Project: **Lincoln Ave. Main Replacement**

CWO No.: **05-106**

Addendum No. 1

CWO NO. 05-106	LINCOLN AVE. MAIN REPLACEMENT ADDENDUM 1	REV A
SCALE: 1"=100'	DWN BY: TAD	SHEET: 1 OF 1

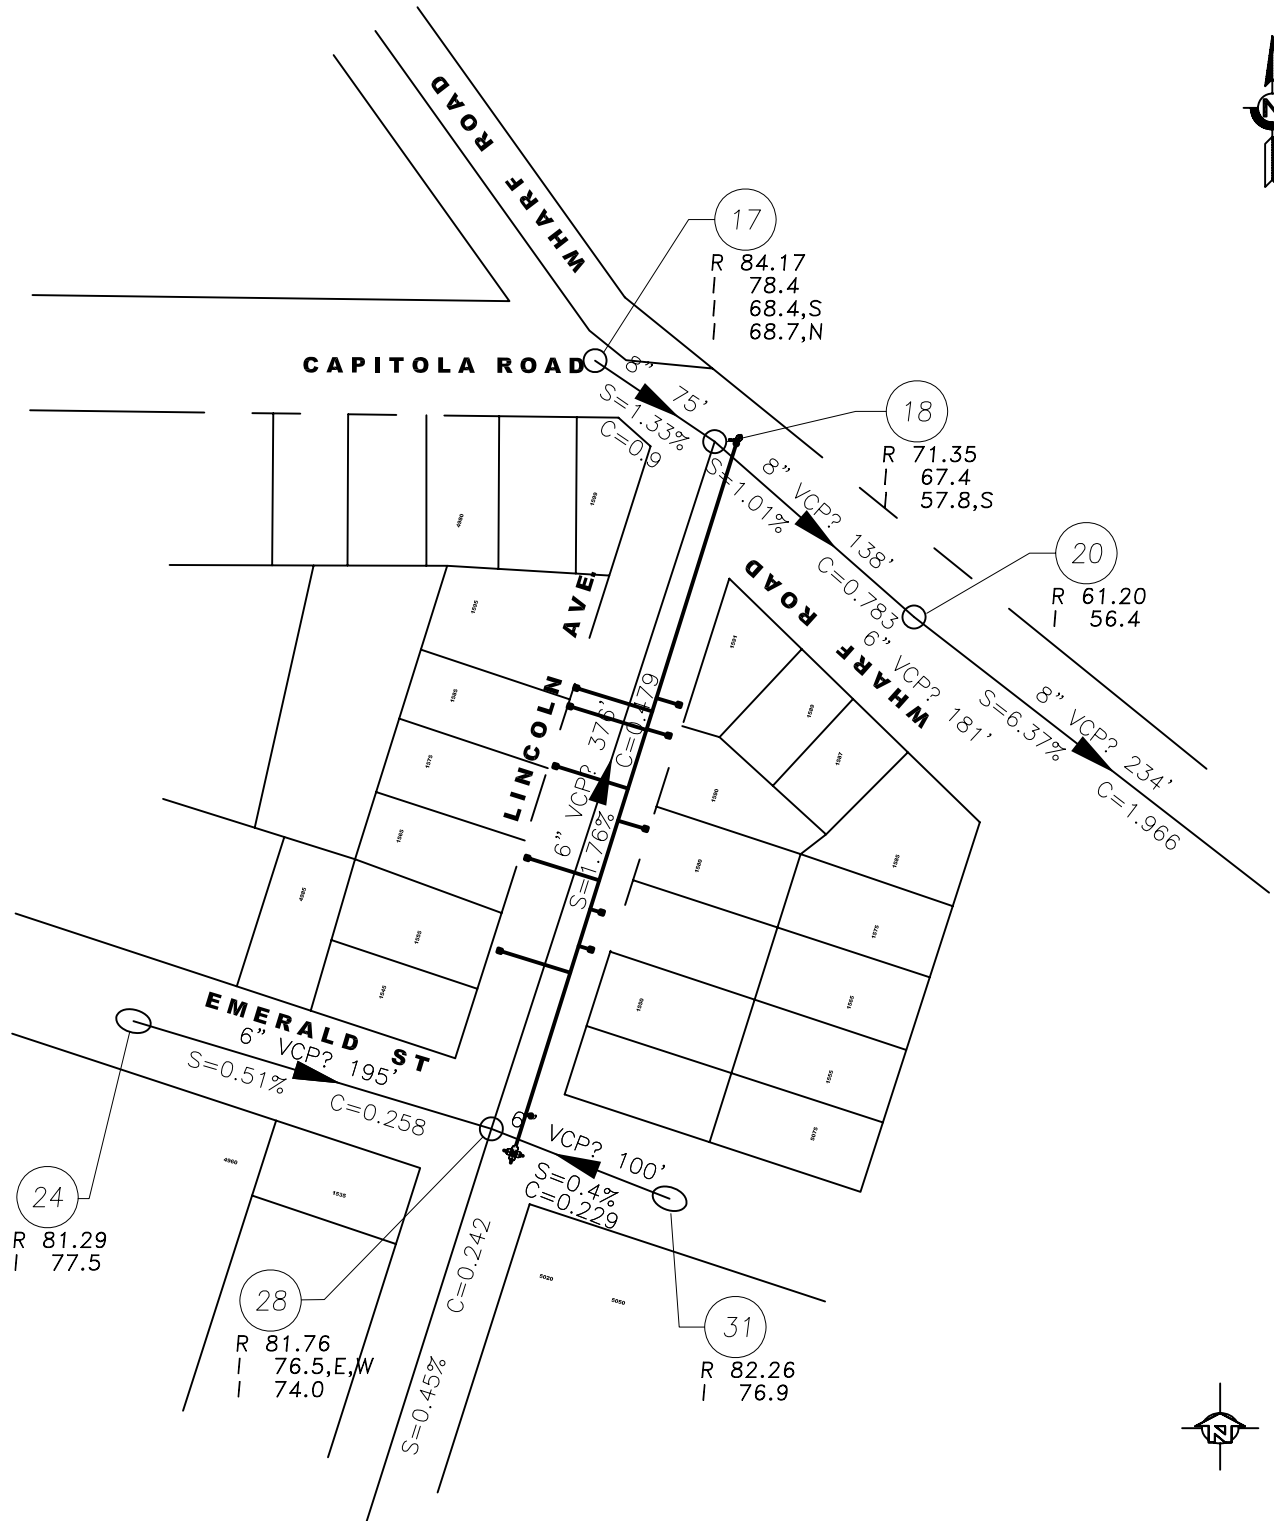
- Project plans have been revised to show sanitary sewer rim and invert elevations. The attached drawing provides depths of sewer mains as provided by the County Sanitation Department. The Contractor shall review attached drawing and install necessary fittings in order to avoid conflict with sewer main and laterals.
